REMARKS

Claims 1 through 20 are pending in this application. Claims 1, 5, 7, 10, 12, 16, 17 and 19 are amended in several particulars for purposes of clarity in accordance with current Office policy, to assist the examiner and to expedite compact prosecution of this application.

FIG 5

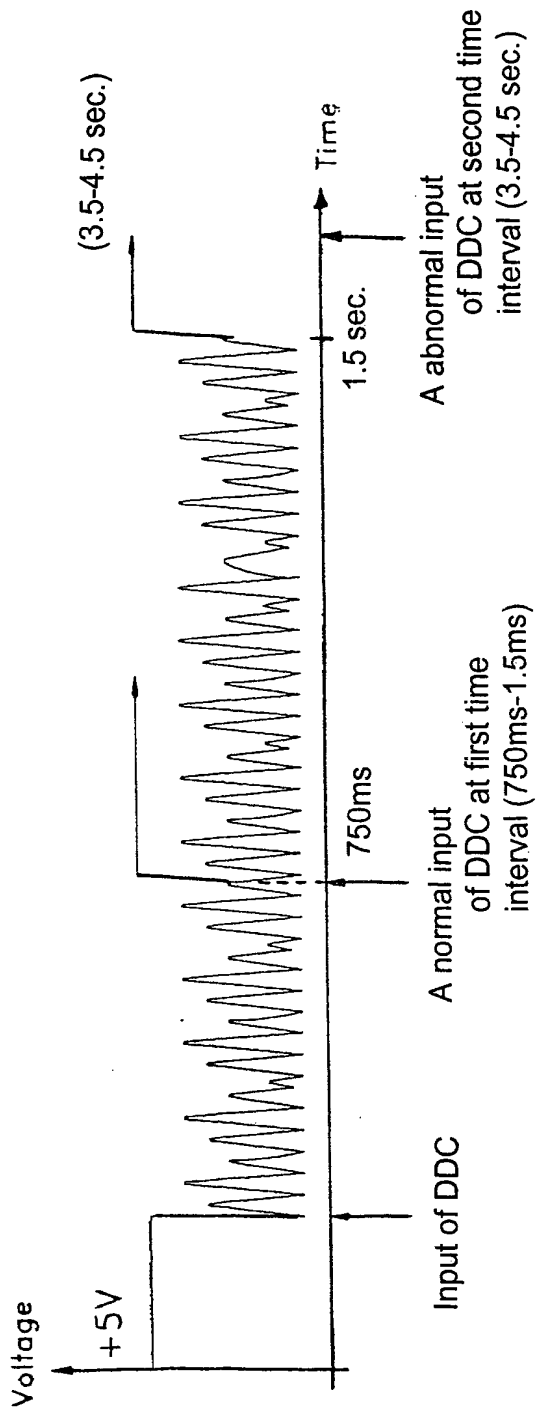
The Examiner objected to the drawings because the Examiner stated that the relay 20 comprising "R1 and R2" should be read --R3 and R4--. Figure 3 has been updated according to the Examiner's suggestion, but with R1 amended to R4 and R2 amended to R5 because as seen below R3 is already used. Further, in order to assist the Examiner in expediting the compact prosecution of the present application, a similar amendment was made in figure 5. According to 37 CFR 1.121 Manner of making amendments in application:
